Seismic Design Margin Evaluation of Systems and Equipment Required for Safe Shutdown of North Anna, Units 1 and 2, Following an SSE Event

**U.S. Nuclear Regulatory
Commission**

Office of Nuclear Reactor Regulation

NUREG-0792

Figure 1. Some typical ductwork support configurations.

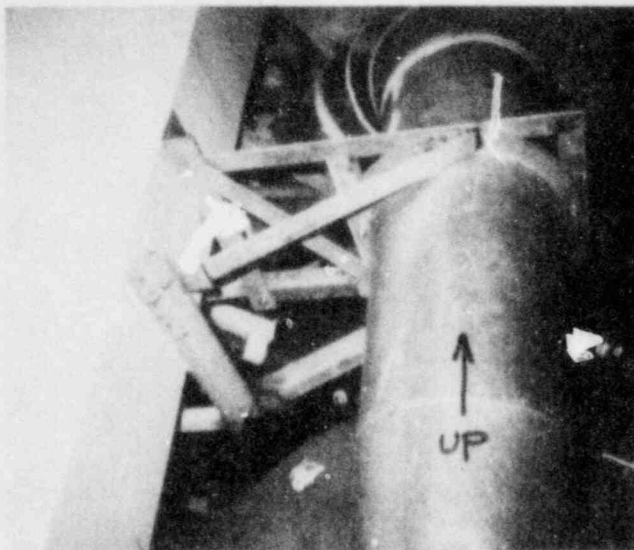
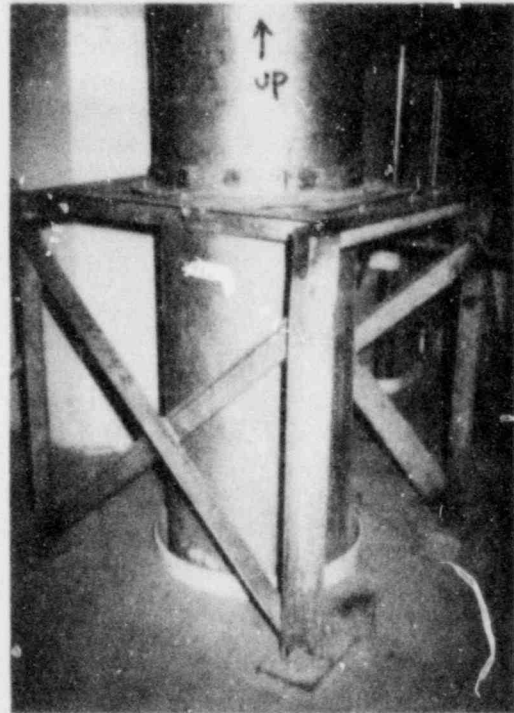
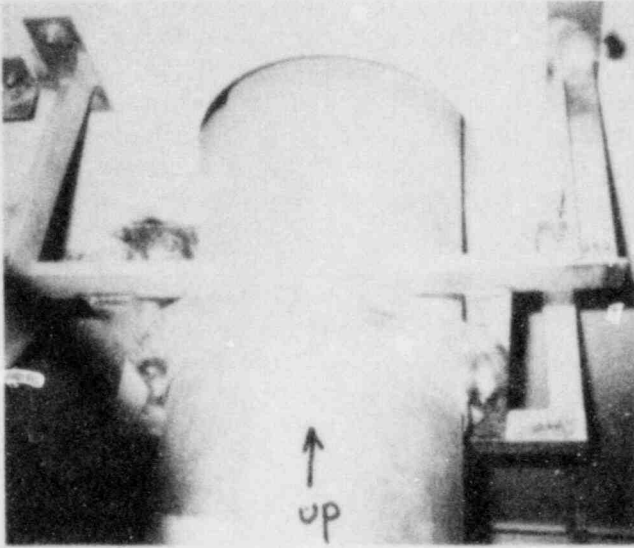
During the discussion at the March 9, 1978 meeting, ACRS members raised specific questions about the seismic design margin of the HVAC ductwork supports and requested more information regarding the margin for drilled-in anchor bolts. In response to these concerns, the staff has reviewed these areas in more depth; the results of this review are included in Sections 3.2 and 3.3 below.

Finally, the STRUDL computer program** has been used to analyze each ductwork support frame member in the North Anna HVAC system. For loads based on a maximum normal ground acceleration of 0.12 g, the stresses on frame members have been found to be relatively small. The design margin for an SSE event for ductwork-support frame members is in excess of +2.0. Figure 1 shows some typical ductwork support configurations in the plant.
